M.I.L "ON" DTC P2195, P2197, P0138, P0158, P0171, P0174, P0031, or P0051

Service Category Engine/Hybrid System

Section Engine Control

Some 2005 – 2007 model year Avalon and 2007 – 2008 model year Camry vehicles with 2GR-FE engines may exhibit a M.I.L. "ON" condition with one or more of the following DTCs:

- (2) Uniformly loosen and remove the 6 nuts. **Figure 1.**

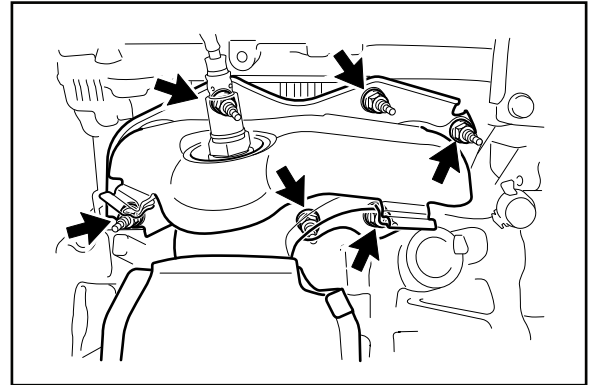
B. Bank 1 (RH) Exhaust Manifold Sub-assembly:

- (1) Disconnect the air fuel ratio sensor connector clamp.

Figure 2.

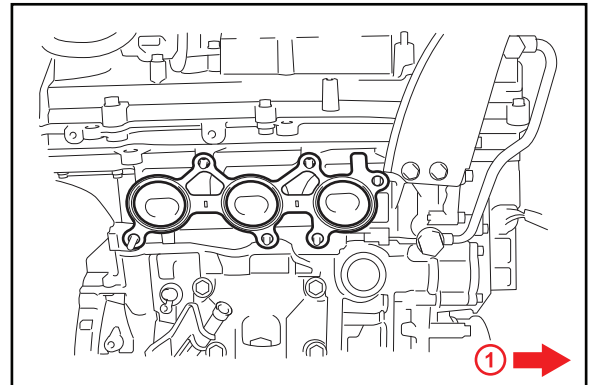
- (3) Remove the manifold and gasket.
- (4) Install a NEW gasket as shown.

- (5) Install the NEW exhaust manifold sub-assembly RH with the 6 nuts and reassemble in reverse order.
Torque: 21 N*m (214 kgf*cm, 15 ft*lbf)

NOTE
 The revised A/F sensor is not compatible with the previous A/F sensors or previous Bank 1 (RH) exhaust manifold.
